**AGENDA  
CITY OF CEDAR FALLS, IOWA  
PLANNING AND ZONING COMMISSION MEETING  
WEDNESDAY, JUNE 09, 2021  
5:30 PM AT CITY HALL AND VIA VIDEO CONFERENCE**

TO: Planning & Zoning Commission
FROM: Michelle Pezley, Planner III
Matthew Tolan, EI, Civil Engineer II
DATE: June 2, 2021
SUBJECT: Pinnacle Prairie South Commercial Phase V preliminary and final plat.

**TO:** Planning & Zoning Commission  
**FROM:** Michelle Pezley, Planner III  
**DATE:** June 2, 2021  
**SUBJECT:** UnityPoint Clinic Site Plan: Case # SP21-006

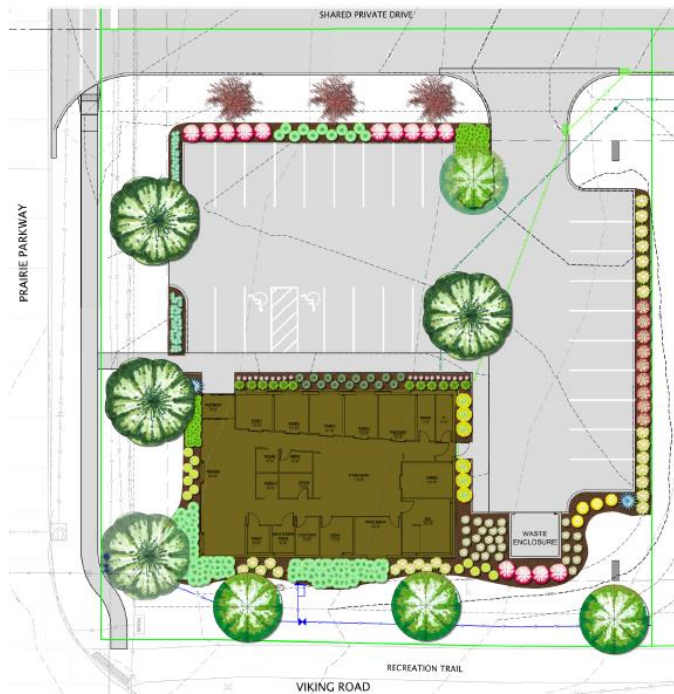
Landscaping is shown throughout the site, both around the building as well as within the parking lot, along the streets, and required setbacks. For clarity, the 3,886 square feet is the provided green space in addition to the landscaped setback.

**The open green space exceeds the minimum requirement and is well distributed.**

- 5) Landscaping: The HWY-1 District requires landscaping at the rate of 0.02 points per sq. ft. of total development site area which comes to 620 points required. Their plan achieves 835 points. An additional 450 points are required for street tree planting and their plan achieves 520.

Trees are required in the vehicular use area at the rate of one overstory tree per 15 parking spaces. This equates to a requirement of 2 overstory trees. That is the amount proposed within the parking area to meet this requirement.

1 NORTH ELEVATION COLOR  
1/8" = 1'-0"

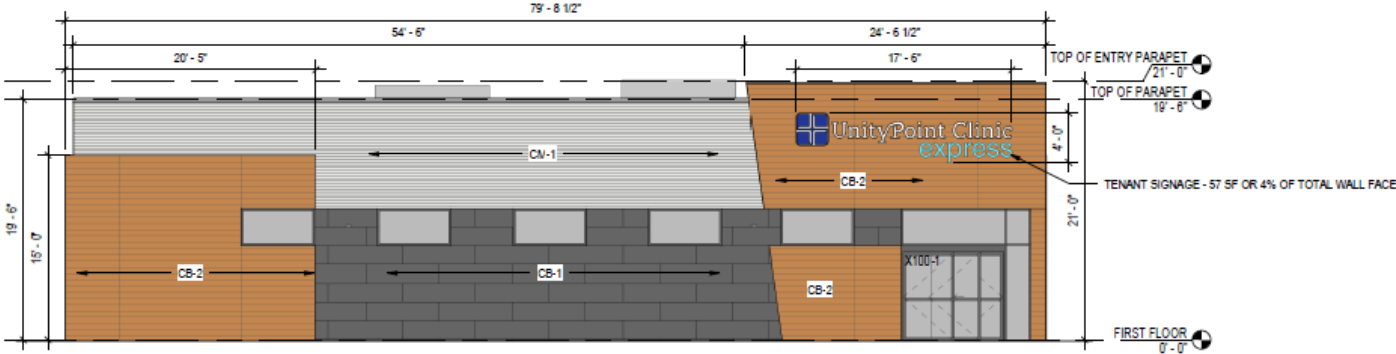
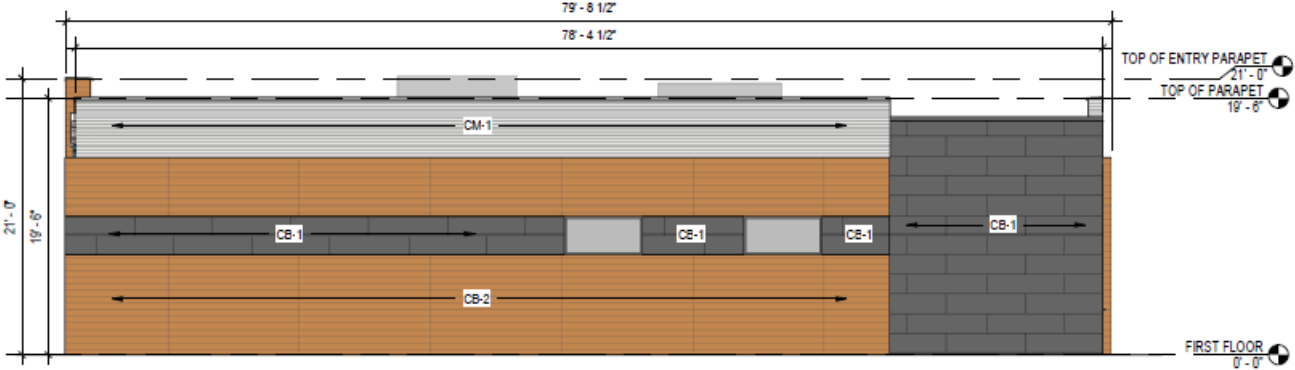
The applicant proposes windows, fiber cement siding, and corrugated metal panels for the new building's exterior materials. All of the materials provide a sleeker modern feel that strikes a balance between color and texture. Staff finds that these material and texture choices are compatible with those of adjacent buildings.

The applicant proposes the building features to be a very neutral color palate. The applicant proposes a dark gray fiber cement, a redwood fiber cement vertical panels, and light gray corrugated metal accent panels. The fiber cement siding is an inconspicuous gray cobblestone color that blends in with the color scheme. Staff finds no issues with the choice of colors.

3 TRASH ENCLOSURE - TYPICAL ELEVATION  
1/4" = 1'-0"

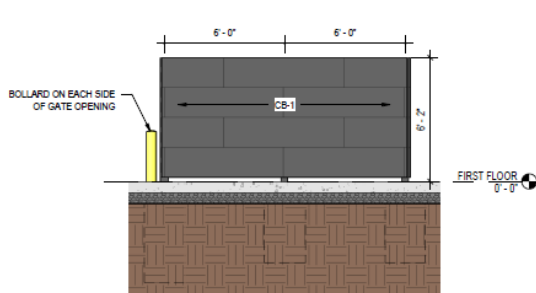
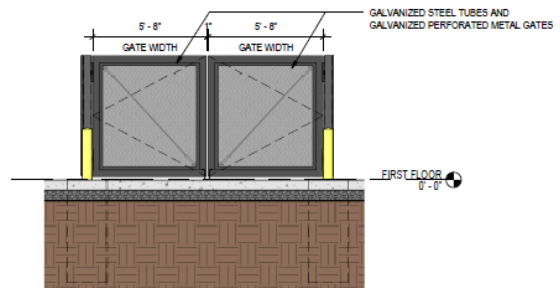
- 7) **Trash Dumpster Site:** The dumpster and enclosure is located on the south edge of the property. This enclosure will be made of fiber cement and metal to match the materials used on the principal structure. It will have two doors to operate towards the north where a truck can approach it. The enclosure will measure 15 feet by 14 feet and will be 6 feet high. **The dumpster facility location and enclosure is acceptable.**
